**USACE Portland District (NWP) FFDRWG Update Form**  
**June 1, 2016**

Project Title	Lamprey Minor Fishway Modifications
SCT Reference Number	
Project Manager (PM)	Mike Turaski (NWP, 503-808-4704)
Technical Lead (TL) Minor Modifications	Sarah Knowles (NWP, 503-808-4980)
Biologist/Coordination	Ricardo Walker (NWP, 503-808-4709)

ADULT FISH COLLECTION AND MONITORING FACILITY  
FOLLOW-ON PHASE III  
KEY PLAN  
MECHANICAL FEATURES

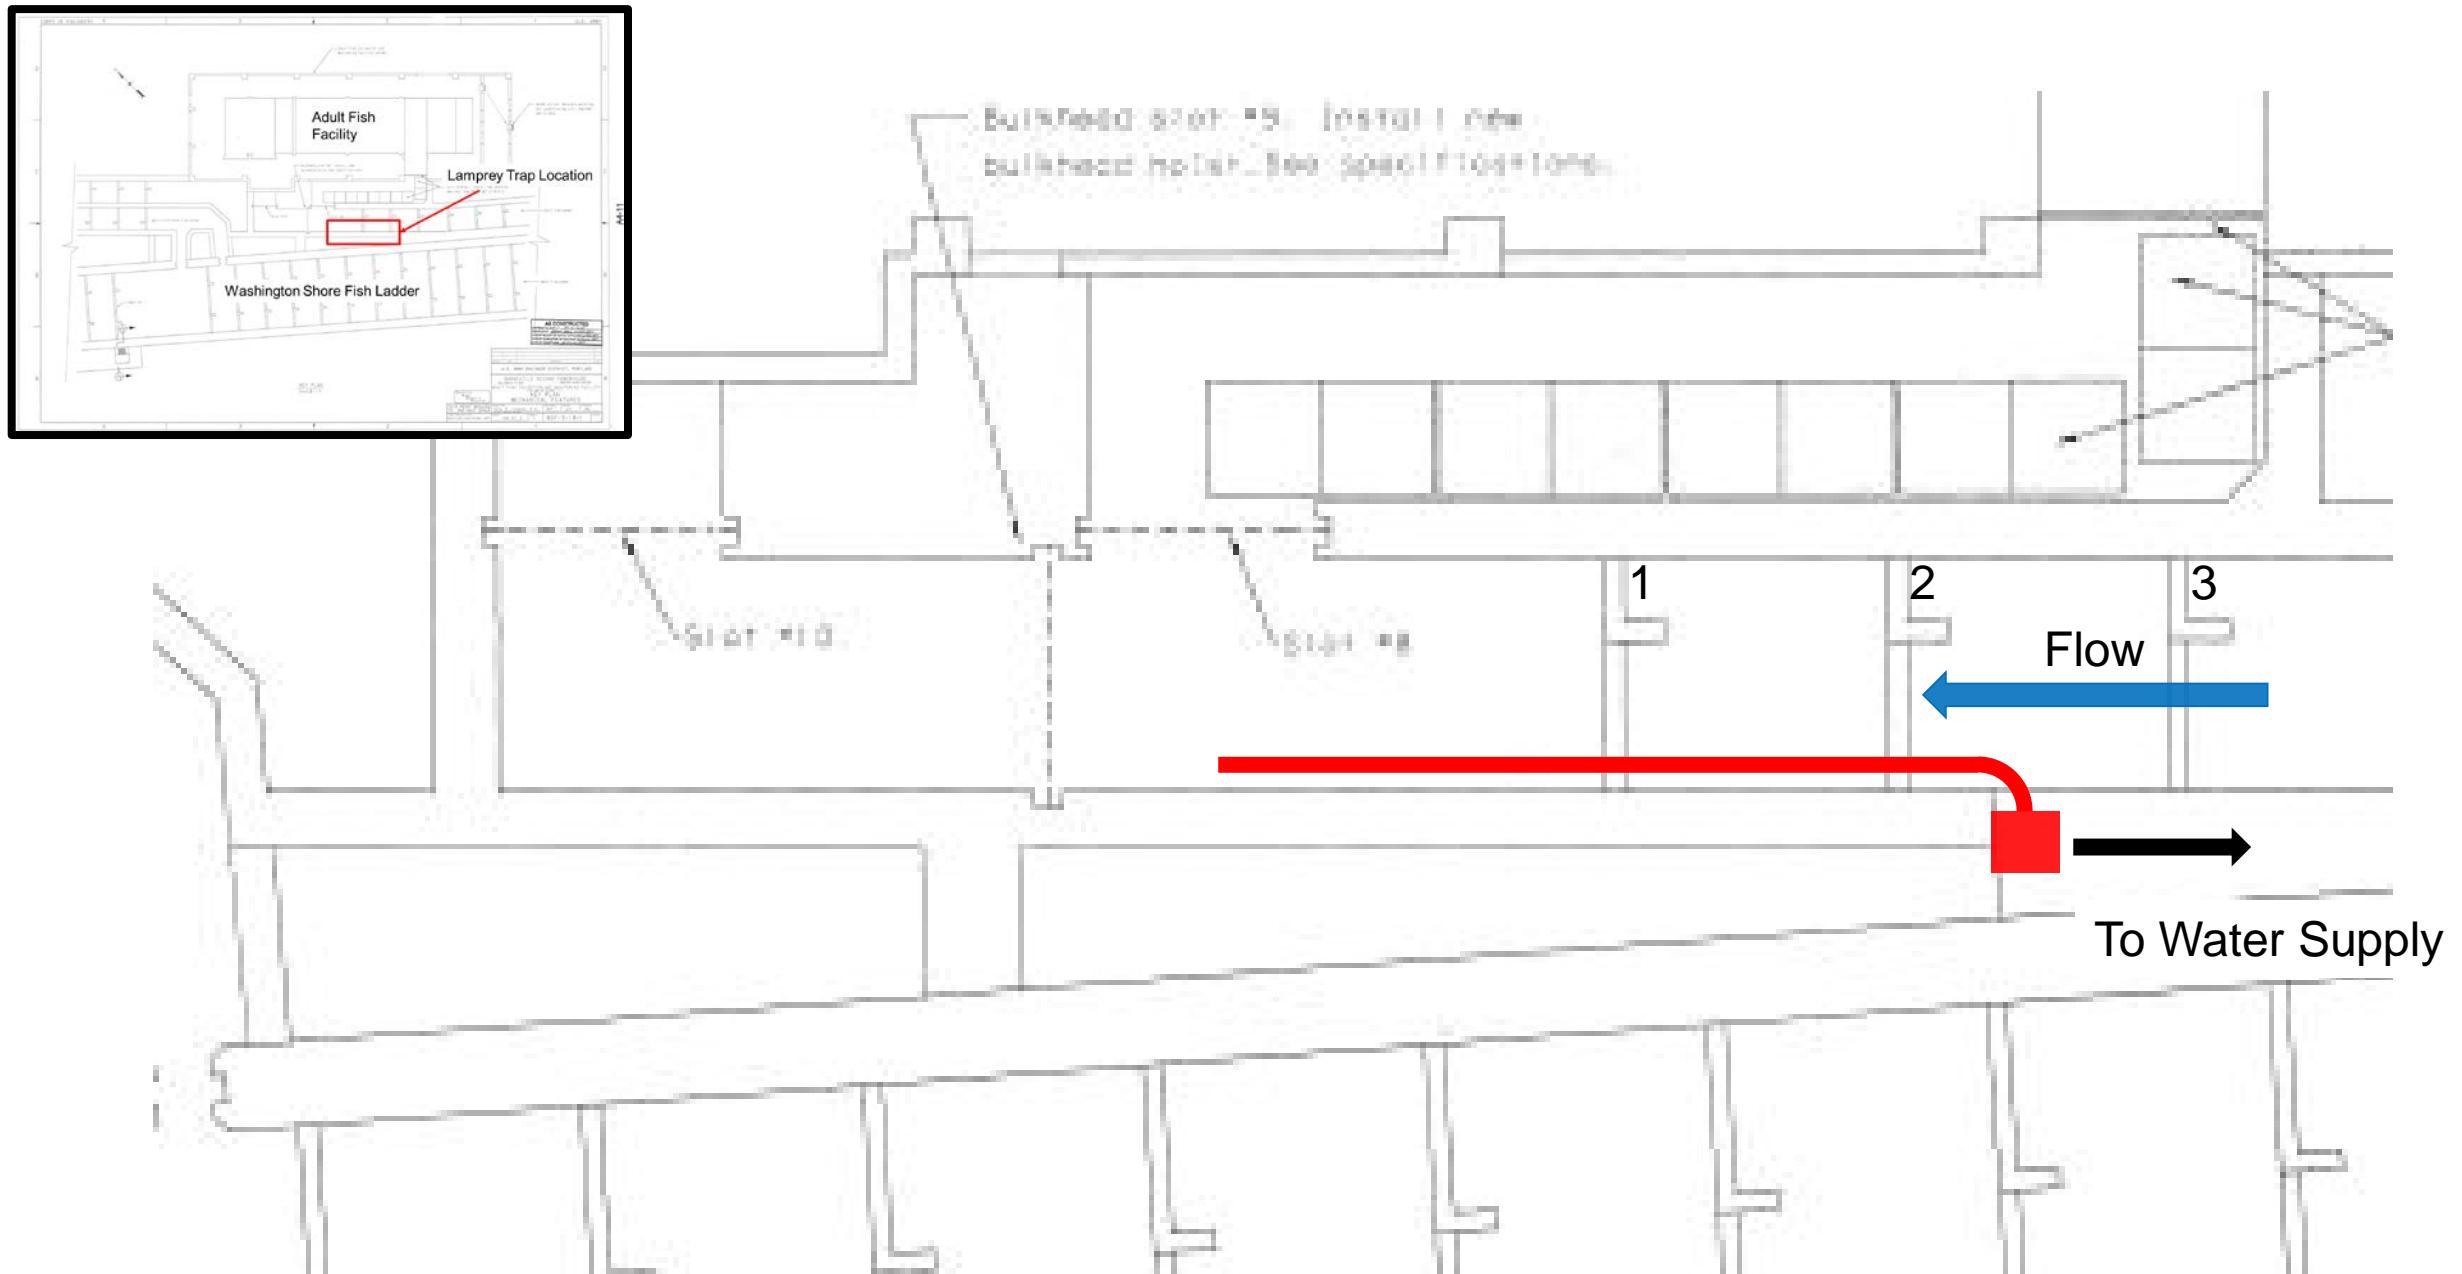
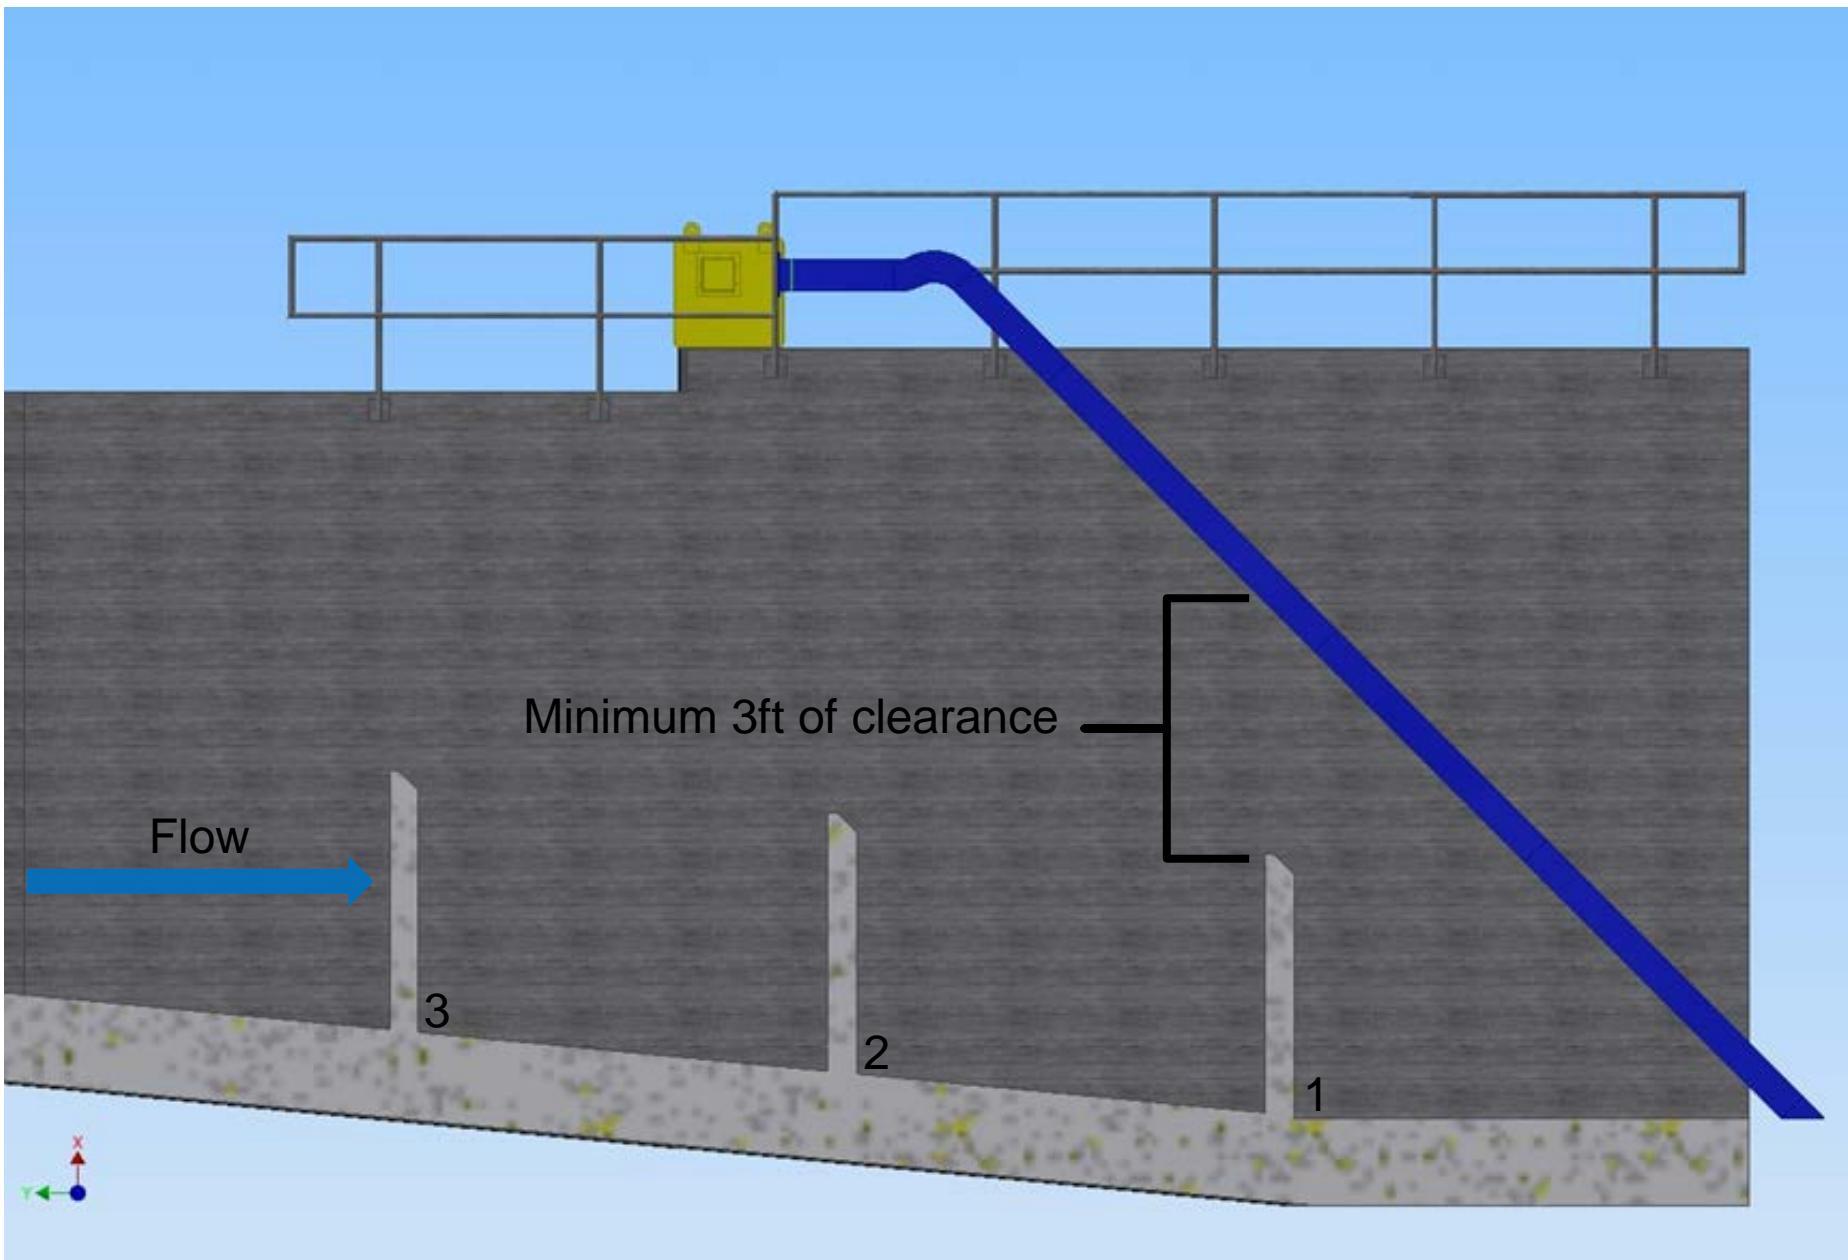
- 18 inch fixed ramp
- Increase in average velocity from 0.8 ft/s to 1.0 ft/s (channel ladder velocity criteria 1.5 – 4 ft/s)

Missing from drawing

- Water supply pipe / hose (source AFF truck fill)
- Potential diffuser in floor of rest box
- Knee brace supports for the flume
- Flume to include a "jog" to avoid interference with the handrails
